- a) **DOV/23/00678 - Creation of 1.5-metre-wide access through boundary wall (Listed Building Consent)**

DOV/23/00679 - Variation of Condition 2 (approved plans) for amendments to DOV/17/00246 relating to pedestrian access and creation of opening in listed wall (Section 73) (Erection of 9 detached dwellings, landscaping, creation of vehicular access and parking) (Variation of Condition)

The Old Rectory, Church Hill, Eythorne

Figure 2: Part site plan, showing off site highway works -revised scheme (not to scale)

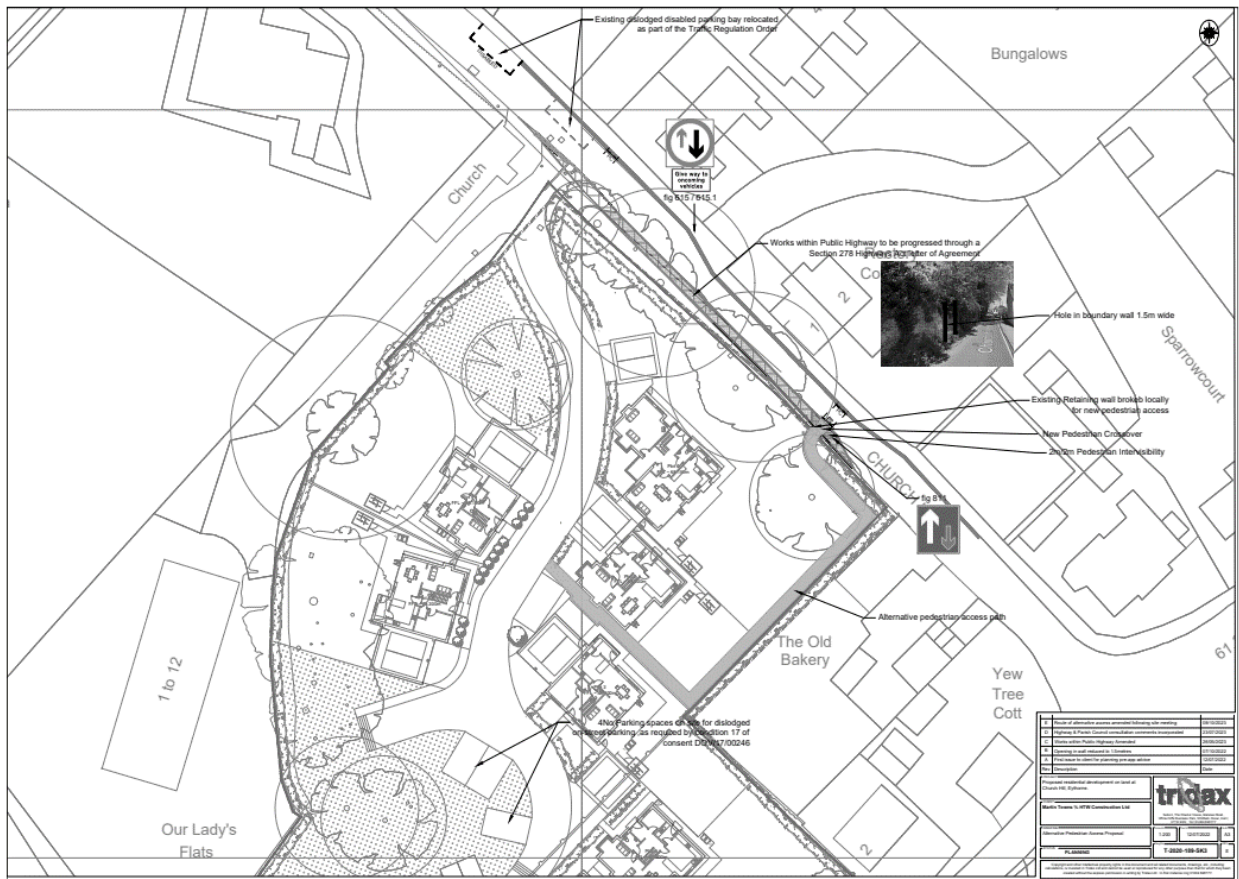
KCC Highways – *Initial consultation*: The amended plans appear to retain the on-street parking restrictions as approved within application DOV/17/00246 which will continue to allow two vehicles to pass each other whilst one is waiting to give way at the narrowing and to allow suitable turning and passing room at the location of the site access. However, due to the relocation of the crossing pedestrian visibility splays of 2m x 2m are required for further assessment, there should be no obstruction over 0.6m within these splays and they should fall within land that is under the control of the applicant or KCC. The uncontrolled crossing will also require a stage 1 road safety audit being undertaken at this stage. Therefore, KCC would be grateful if amended plans inclusive of pedestrian visibility splays were submitted by the applicant, in addition to a stage 1 road safety audit so that further assessment may be made.

Third consultation: An alternative pedestrian access path plan has been submitted however the reason for amending the prior plans are unclear. The alternative path is both narrower and longer, with hard boundaries on either side which may reduce accessibility. It is acknowledged that prior plans indicate the path is on a gradient, this gradient should be confirmed to further assessed the proposed plans. KCC Highways would be grateful therefore if you would forward any amended plans or additional information to me for my further consideration.

- Highway safety. The proposed pedestrian footway along the western side of Church Hill to create a suitable access for pedestrians, will cause a significant and unexpected narrowing for vehicles entering Church Hill from Wigmore Lane, Shepherdswell Road and Shooters Hill. This could lead to vehicle accidents and possible queuing of vehicles out onto the White Horse crossroads.

- 2.48 KCC Highways have advised that due to the relocation of the pedestrian crossing, pedestrian visibility splays of 2m x 2m are required with no obstruction over 0.6m within these splays and they should fall within land that is under the control of the applicant or KCC. The uncontrolled crossing will also require a stage 1 road safety audit being undertaken at this stage.

- 2.50 KCC Highways were also consulted on the revised scheme for an alternative pedestrian access path (seeking to reduce impact on trees). KCC Highways stated that this revised scheme indicates a path that is longer, with hard boundaries on either side which may reduce accessibility. It is acknowledged that prior plans indicate the path is on a gradient, this gradient should be confirmed to further assessed the proposed plans.

Second consultation following receipt of amended plans: No objection provided the following requirements are secured by condition or planning obligation:

- Provision and maintenance of the pedestrian visibility splays shown on the submitted plans with no obstructions over 0.6 metres above carriageway level within the splays, prior to the use of the site commencing.
- Prior to the commencement of development submission and approval of detailed designs for the pedestrian crossover as indicatively shown on the submitted plans T-2020-189-SK3 Rev D. No occupation of any dwellings shall take place until these Highways works have been completed in accordance with a Section 278 agreement with the Highway Authority, unless otherwise agreed in writing by the Highway Authority.

- 2.49 After amended and additional information was submitted KCC Highways raised no objection subject to conditions or planning obligation to secure the provision and maintenance of the pedestrian visibility splays, and submission and approval of detailed designs for the pedestrian crossover as indicatively shown on the submitted plans. The highway works will need to be completed in accordance with a Section 278 agreement with the Highway Authority.

Figure 5: Proposed opening to listed wall (not to scale)

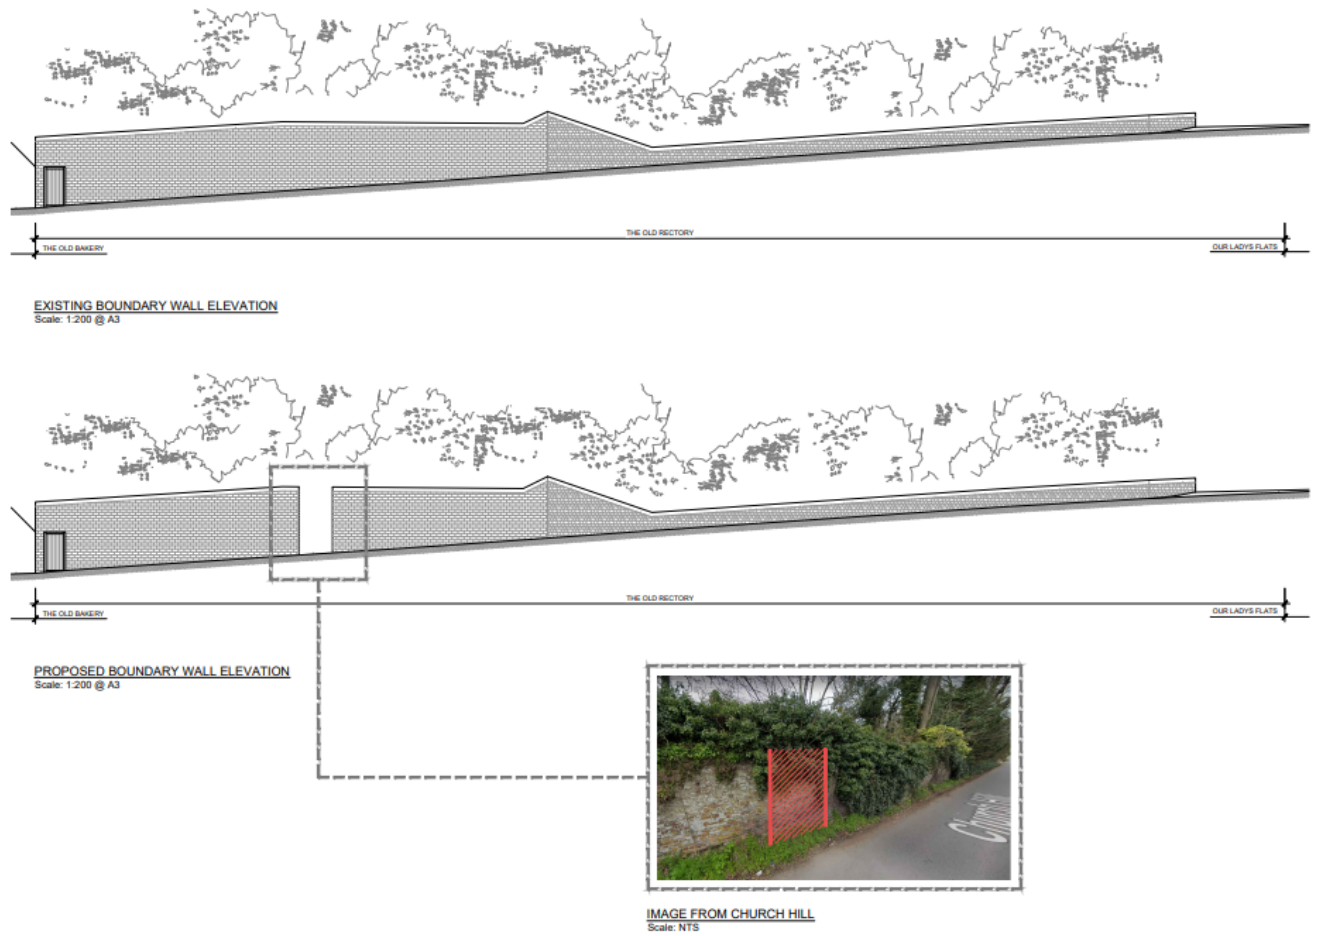
- Effect on listed building and conservation area. The wall that the developer proposes to make an entrance from the site into Church Hill has listed wall status, which would cause irreparable damage to the wall and the heritage of the Village.

DDC Heritage team – The impact of the proposed works to the boundary wall would lead to less than substantial harm and would be at the lower end of the scale, however, this is subject to details. DDC heritage team have suggested a condition is attached to the listed building consent requiring submission of detailed drawings of new opening and any repairs prior to commencement.

- The creation of a gap would affect the structural stability of the wall. The opening of a part of the wall will seriously damage the listed wall and I expect will lead to a further demolition of the wall as rendered not safe.

- 2.30 Draft policies HE1 and HE3 relate to protection of heritage assets and listed buildings.
- 2.31 The proposal would affect the fabric of a listed wall, with a 1.5m wide section of wall removed. Due to the overall amount of the wall to be removed and the significance of the wall itself, it is considered that the proposal would constitute a minor loss and the overall significance of the listed wall is not harmed. The works are considered to constitute less than substantial harm and at the lower end of the scale, however, this is subject to consideration of details.

- 2.32 DCC Heritage have been consulted and recommend the following condition:
Prior to the commencement of the relevant works scale sections at 1:20 showing the proposed new opening including details of any repairs to the existing listed wall necessary as a result of the creation of the new opening shall be submitted to and agreed in writing by the local planning authority and the works thereafter shall be carried out in accordance with the approved detail.

- 1) Standard time condition
- 2) List of approved plans
- 3) Prior to commencement scale sections at 1:20 showing the new opening and details of any repairs to the existing listed wall
